Project	The Falls on Refugee Road	Addendum Number	2
Project Number	23446	Date	06/27/2025
To	All Bidders

Date June 24, 2025
Project Title The Falls on Refugee Road
To All Plan Holders
Purpose Modify the Construction Documents
Distribution

05/01/2025
	23446
	C214
	CD PROGRESS SET

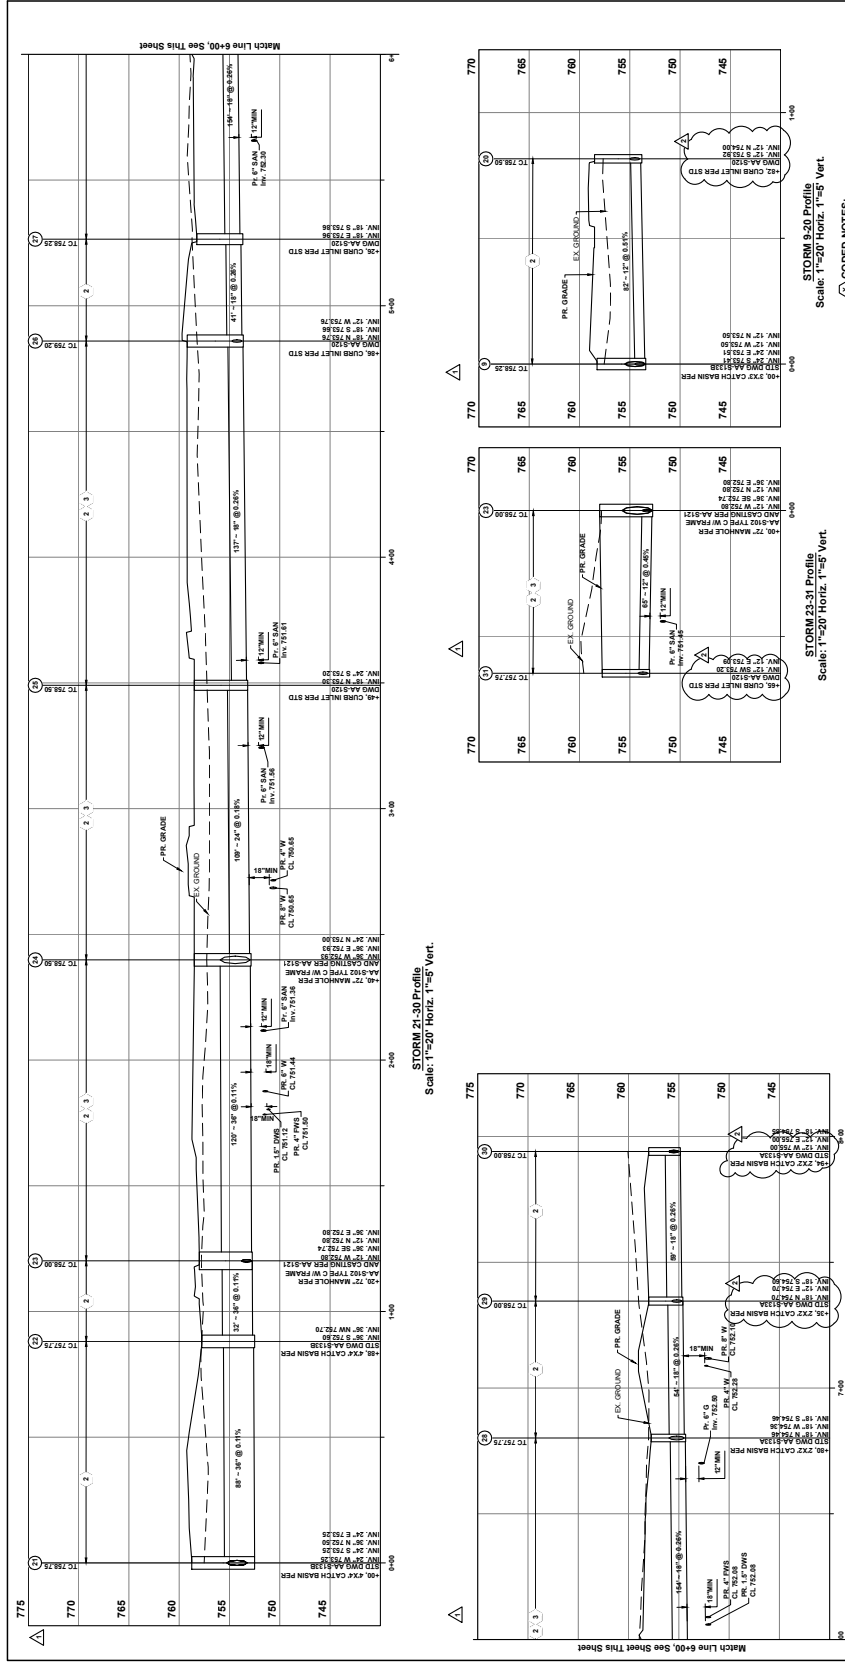
9. SHEET C214 – STORM SEWER PROFILES
 - A. **ADD** roof drain inverts to structure 6, 16, and 19 in profile.

05/01/2025
	23446
	C220
	CID PROGRESS SET

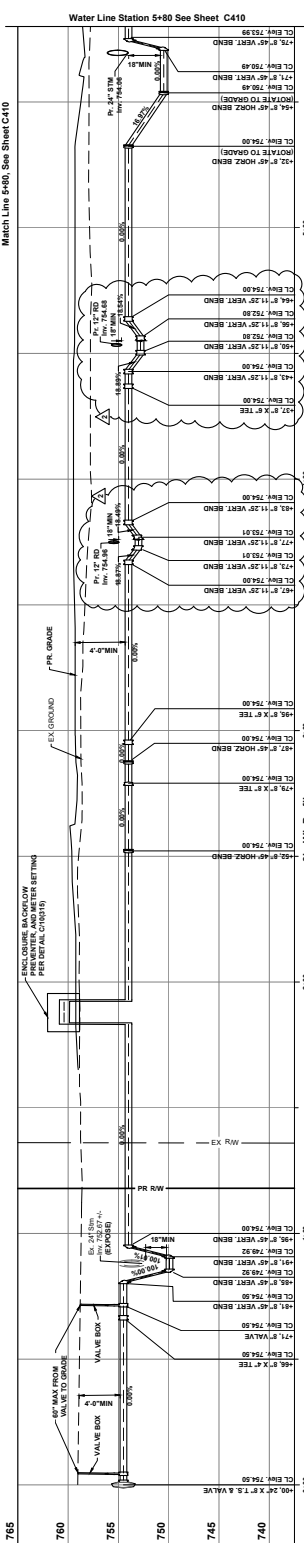
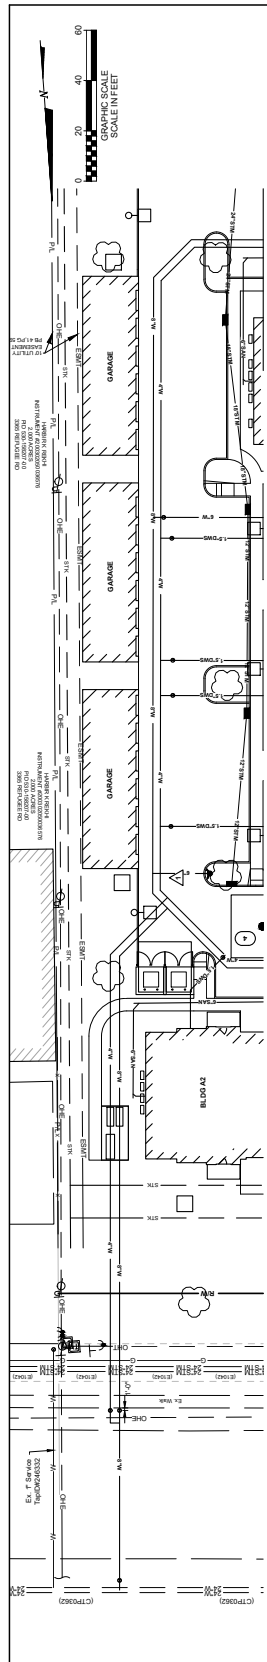
14. SHEET C220 – EROSION AND SEDIMENT CONTROL PLAN

- A. **ADD** downspouts and roof drains with associated cleanouts
- B. **REVISE** construction entrance and concrete washout location.

PROGRESS DRAWING NOT FOR CONSTRUCTION		C410	23446	05/01/2025
	CD PROGRESS SET

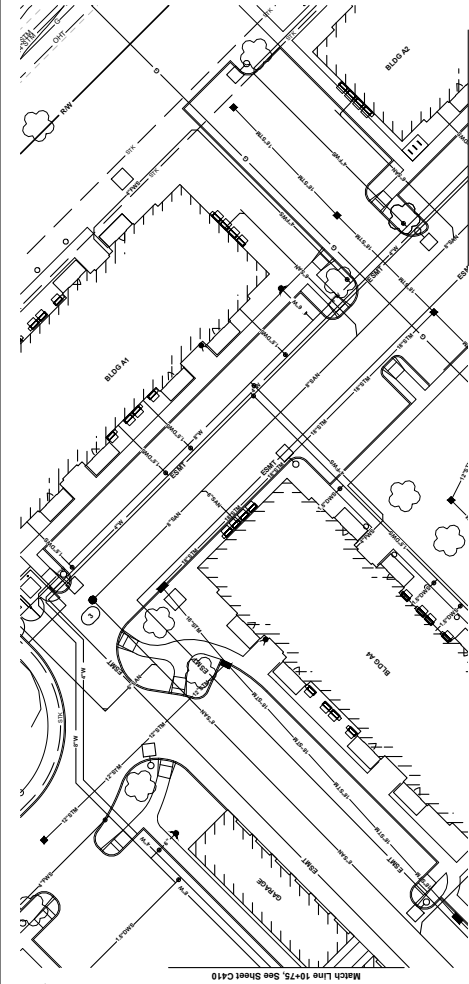
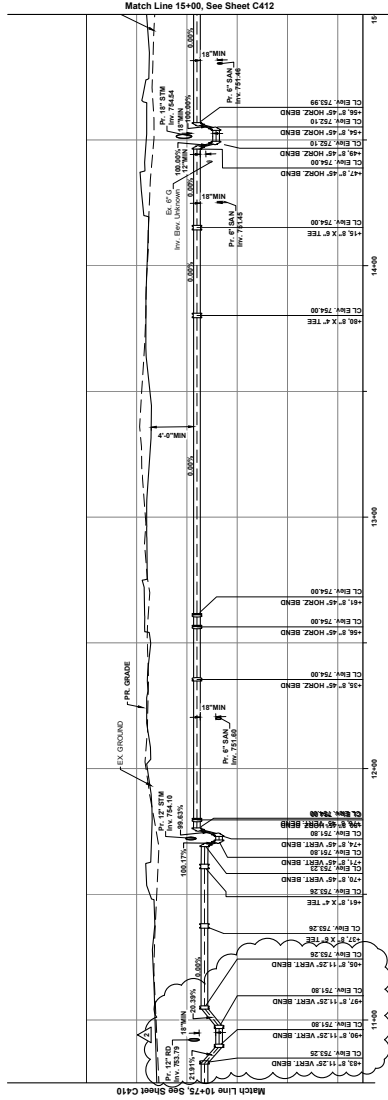
22. SHEET C410 – WATER SERVICE PLAN & PROFILE

- A. **ADD** roof drain crossings.
- B. **REVISE** sheet number.

STAIR LANDING FRAMING PLAN

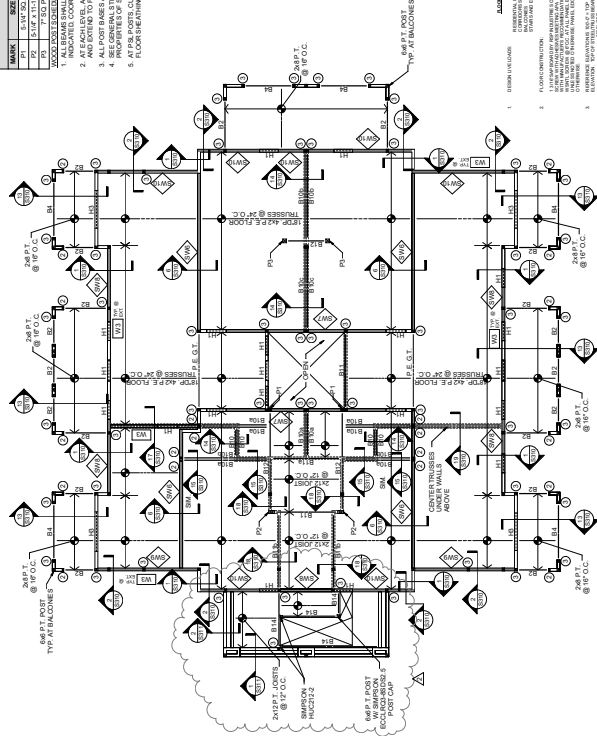
S107-D – 2nd Floor Framing Plan (Building D)

- 1) Revised west stairs.
- 2) Added the stair landing framing plan for west stairs.
- 3) Updated the wood beam schedule.
- 4) Added details 1&2/S311 for west stairs.

PROGRESS DRAWING NOT FOR CONSTRUCTION	06/01/2025
	23446
	A201A
	CD PROGRESS SET

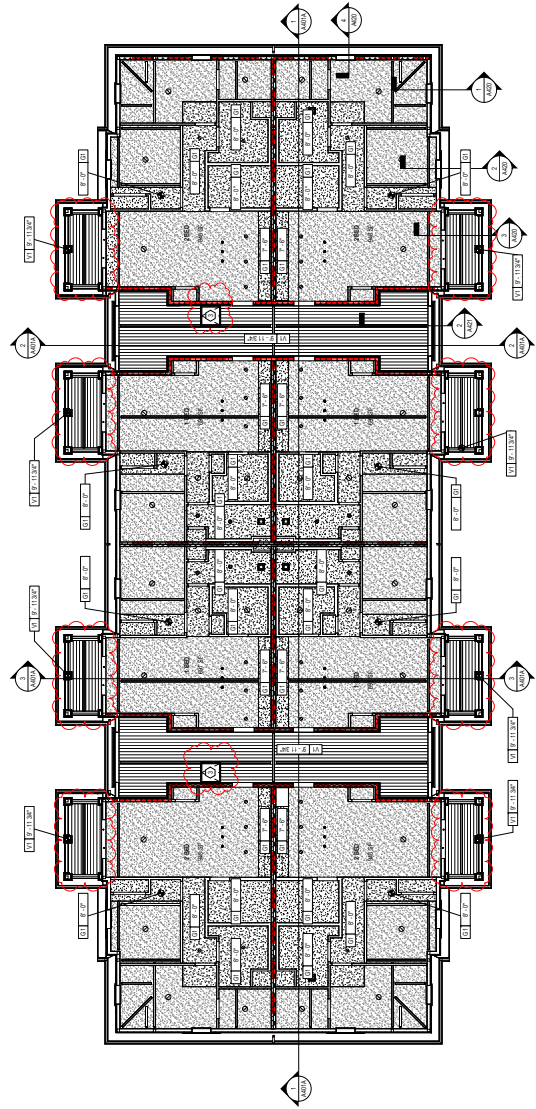
- 10) A201A – BUILDING A LEVEL 01 & 02 RCP
- i) Added rated gyp ceiling G2 to sprinkler rm
 - ii) Removed vinyl soffit at breezeway
- 11) A202A – BUILDING A LEVEL 03

PROGRESS DRAWING NOT FOR CONSTRUCTION	05/01/2025
	23446
	A202A
	CD PROGRESS SET

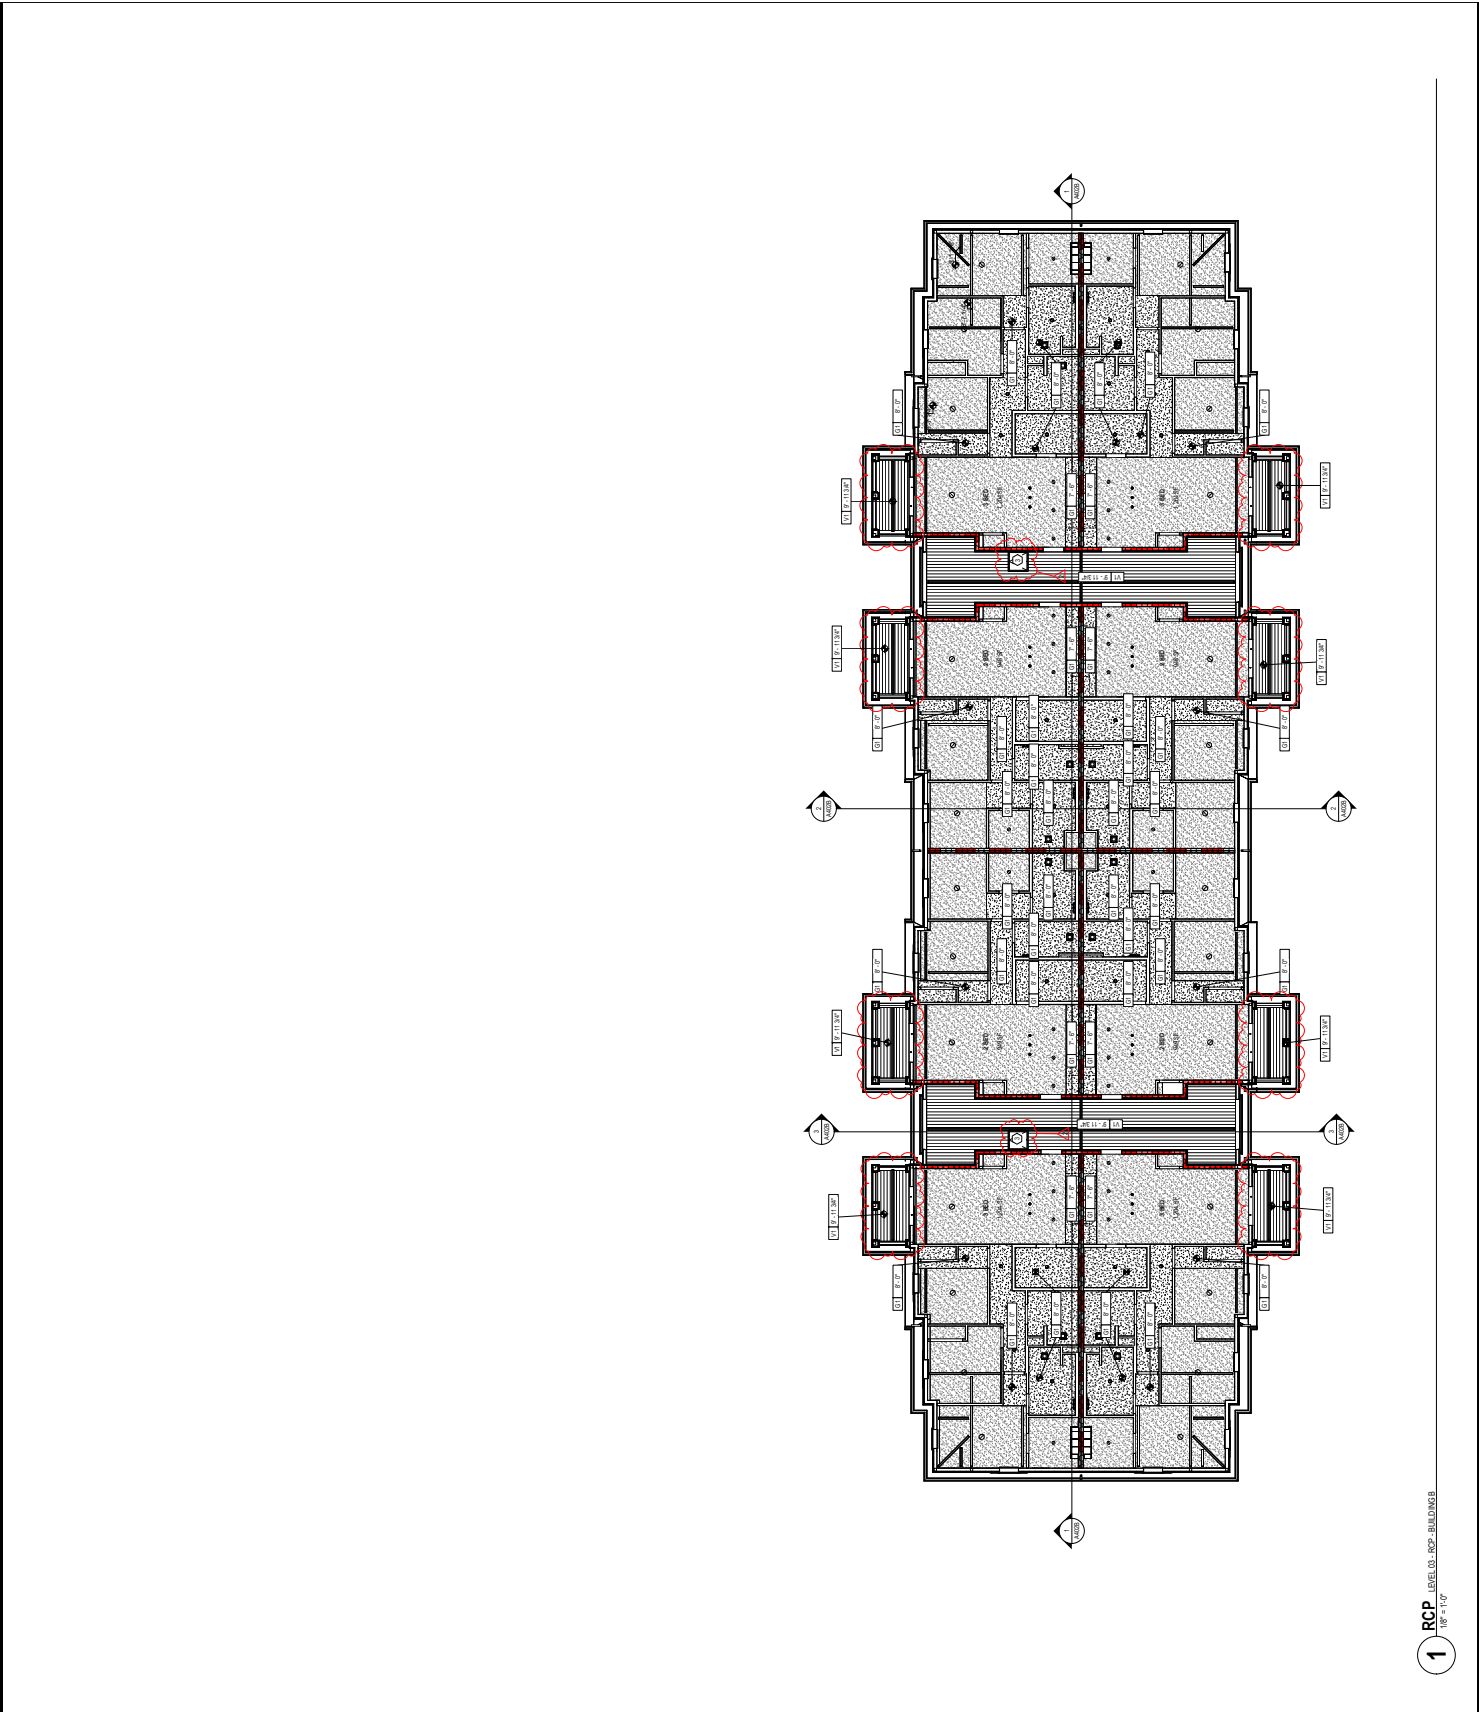
- i) Relocated attic access panel
 - ii) Revised breezeway ceiling to vinyl soffit
 - iii) Added dimensions to balcony vinyl soffit
- 12) A203B – BUILDING B LEVEL 01 & 02 RCP

PROGRESS DRAWING NOT FOR CONSTRUCTION 05/01/2025 23446 A310B CD PROGRESS SET

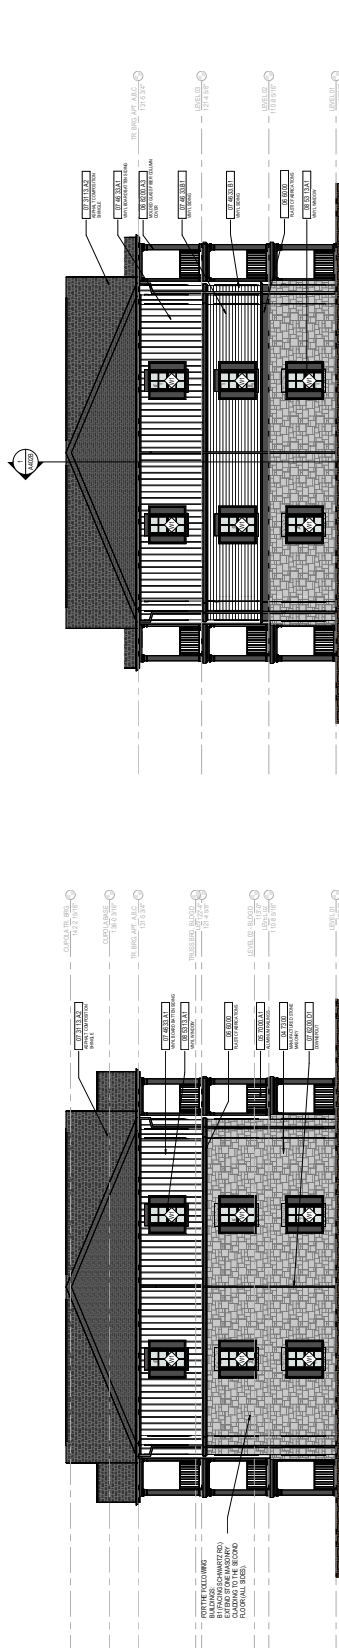
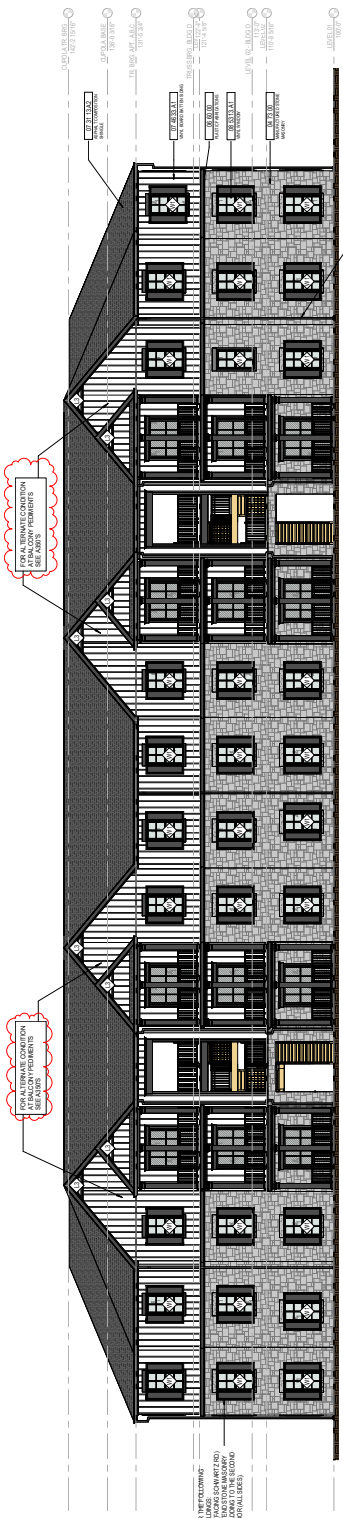
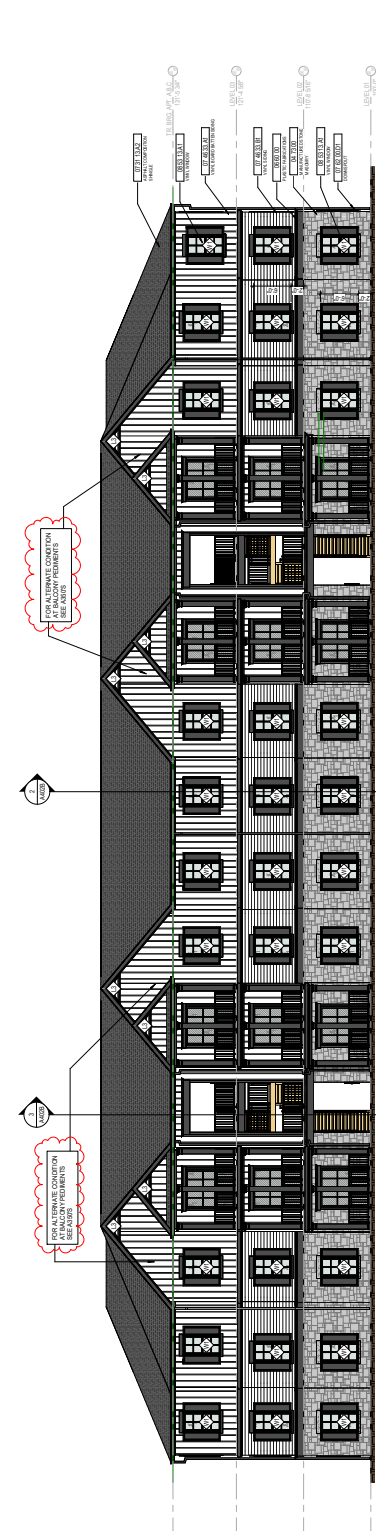
- 17) A310B – BUILDING B ELEVATIONS
- i) Revised note for alternate to direct to A350
- 18) A310C – BUILDING C ELEVATIONS
- i) Revised note for alternate to direct to A350

05/01/2025	23446	FP105-C	CD PROGRESS SET
PROGRESS DRAWING NOT FOR CONSTRUCTION

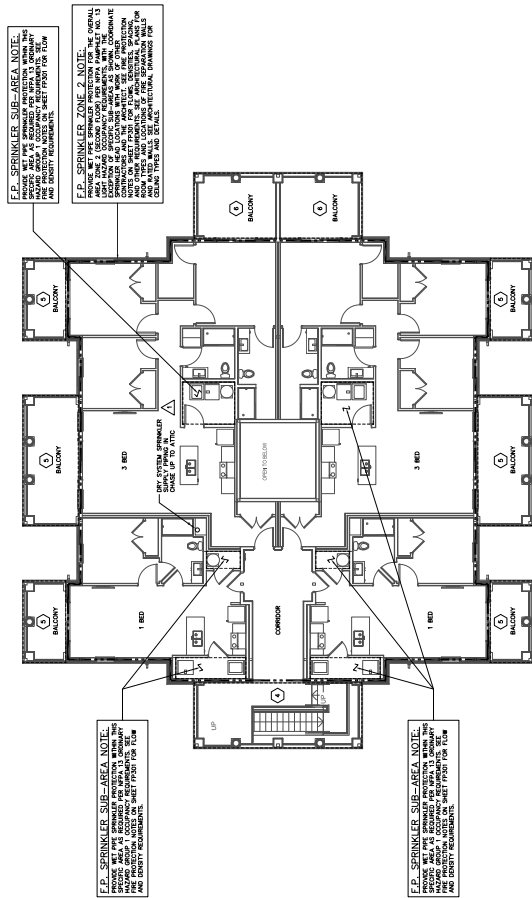
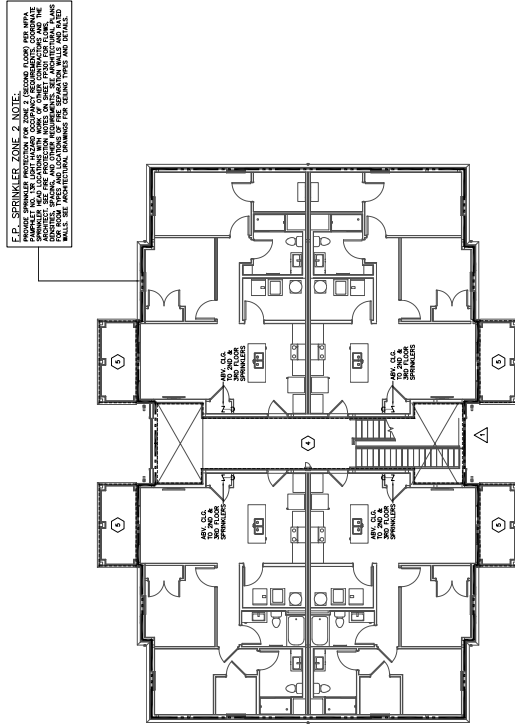
37. On FP drawings FP101A, FP103-B & FP105-C show 2 risers for each Building. One for the 1st level and one for levels 2 & 3. Can we have just one riser for the entire Building? This will save material for the added riser and added main piping. The branchline piping will still rise up in the walls but using sidewalls throughout the entire building or stacks.

- 14. FP101-A – Building A Fire Protection Plans
 - a. Revised fire protection layout for one system riser.
 - b. Revised Coded Notes 6, 7, 8, & 9.
- 15. FP103-B – Building B Fire Protection Plans
 - a. Revised fire protection layout for one system riser.
 - b. Revised Coded Notes 6, 7, 8, & 9.
- 16. FP105-C – Building C Fire Protection Plans
 - 1. Revised fire protection layout for one system riser.
 - 2. Revised Coded Notes 9, 7, 8, & 9.
- 17. FP106-D – Building D Fire Protection Plans
 - 1. Revised Level 01 fire protection layout due to plan updates.
 - 2. Revised Coded Notes.
- 18. FP-201 – Fire Protection Enlarged Plans & Details

Response: One riser per building is acceptable. The drawings have been updated and included in Addendum #2. The sprinkler layout design is the responsibility of the Fire Protection Contractor. The Architect shall approve the general locations of the sprinkler heads. Sprinkler supply riser piping shall not be located in exterior or breezeway wall structures.

**BUILDING A - LEVEL 01 & 02
HVAC PLANS**

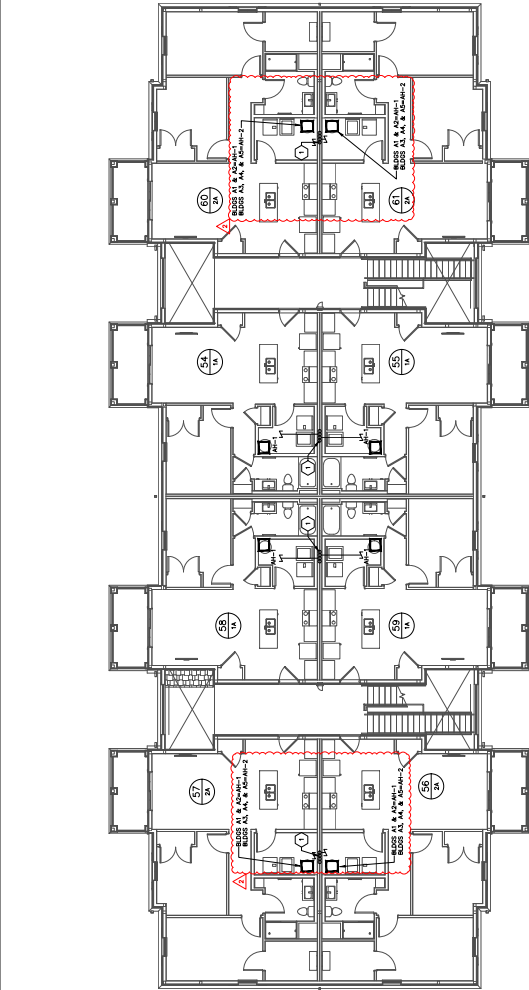
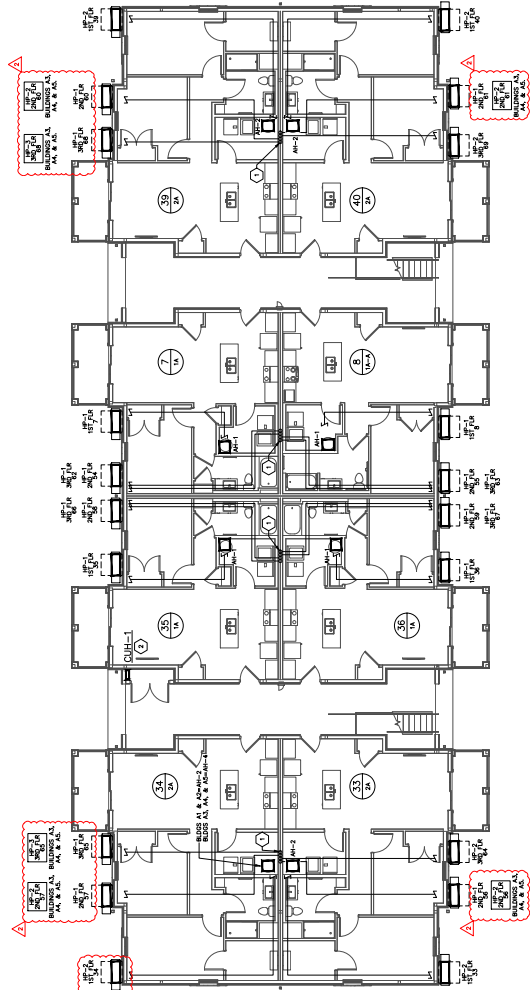
- 1. H100 – HVAC site plan
 - a. Revised outdoor unit layout at the clubhouse.
- 2. H101-A – Building A – Level 01 & 02
 - a. Updated outdoor unit tags to include alternate orientation of building A.
